Access Compliance Report Public Rights-of-Way (Island Curb Cuts)

Intersection ID: 51491 Main Street: N_TRYON_ST Cross Street: INSTITUTE_CR Location: E

ADA ID: A923FB53BEA2 Curb Cut Type: MedianRefuge2 Initial Pass/Fail: Fail Overall Compliance: No Severity Score: 0

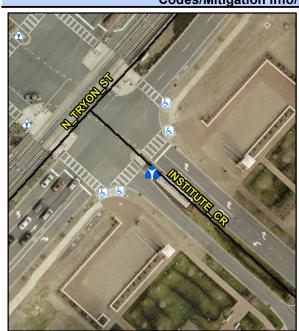
Compliance Description		Data	Data Compliance		
Yes	Refuge 1 Length (In)	71.0	N/A	Gutter 1	
Yes	Refuge 1 Width (In)	141.0	N/A	Gutter 1	
Yes	Refuge 1 Slope (%)	1.8	N/A	Gutter 1	
Yes	Refuge 1 X Slope (%)	2.8	N/A	Gutter 1	
N/A	Painted X Walk1?	No	N/A	DWS 1	
N/A	X Walk 1 Direction	То Е	N/A	DWS 1	
N/A	X Walk 1 Width (In)	N/A	N/A	DWS 1	
N/A	Road 1 Slope (%)	3.3	N/A	DWS 1	
N/A	Road 1 X Slope (%)	3.5	N/A	DWS 1	
Yes	Refuge 2 Length (In)	71.0	N/A	Gutter 2	
Yes	Refuge 2 Width (In)	141.0	N/A	Gutter 2	
Yes	Refuge 2 Slope (%)	1.1	N/A	Gutter 2	
Yes	Refuge 2 X Slope (%)	1.6	N/A	Gutter 2	
N/A	Painted X Walk2?	No	N/A	DWS 2	
N/A	X Walk 2 Direction	То Е	N/A	DWS 2	
N/A	X Walk 2 Width (In)	N/A	N/A	DWS 2	
N/A	Road 2 Slope (%)	2.2	N/A	DWS 2	
N/A	Road 2 X Slope (%)	3.8	N/A	DWS 2	
N/A	Refuge 3 Length (in)	N/A	N/A	Gutter 3	
N/A	Refuge 3 Width (in)	N/A	N/A	Gutter 3	
N/A	Refuge 3 Slope (%)	N/A	N/A	Gutter 3

Remove & Replace Entire Refuge.
